Project	IEEE 802.16 Broadband Wireless Access Working Group < http://ieee802.org/16 >	
Title	Fast Call Recovery for Drop Call during HO	
Date Submitted	[2003-11-07]	
Source(s)	Changhoi Koo Hyunjeong Kang Jung Je Son Samsung Elec. 416, Maetan-3dong, Youngtong-gu Suwon-si, Gyeonggi-do Korea	Voice: +82-31-279-5091 Fax: +82-31-279-5130 chkoo@samsung.com hyunjeong.kang@samsung.com jungje.son@samsung.com
Re:	This contribution is for call for contribution IEEE802.16e-03/07r4	
Abstract	This contribution proposes the Drop ranging code and Drop ranging time offset for providing the fast call recovery operation during handover.	
Purpose	Propose the fast call recovery for the IEEE802.16e Handoff Ad hoc group	
Notice	This document has been prepared to assist IEEE 802.16. It is offered as a basis for discussion and is not binding on the contributing individual(s) or organization(s). The material in this document is subject to change in form and content after further study. The contributor(s) reserve(s) the right to add, amend or withdraw material contained herein.

Fast Call Recovery for Drop Call during HO

Proposed Text Changes

Figure 0h - Example of ranging message flow using drop ranging code and time offset

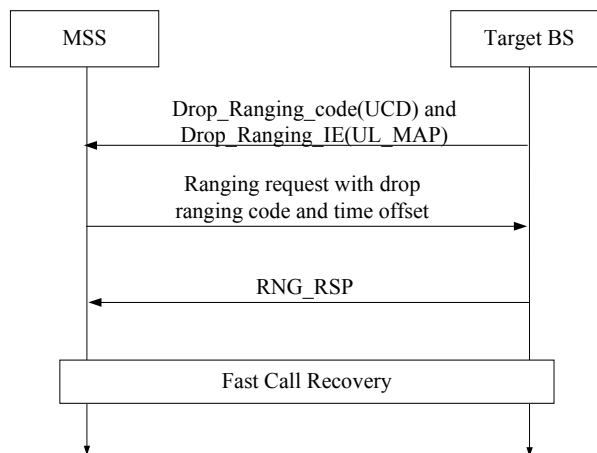
And the following figure and explanation shall be incorporated into the page 12 line 37

The example of ranging message flow using drop ranging code and time offset is depicted in Figure 0h.
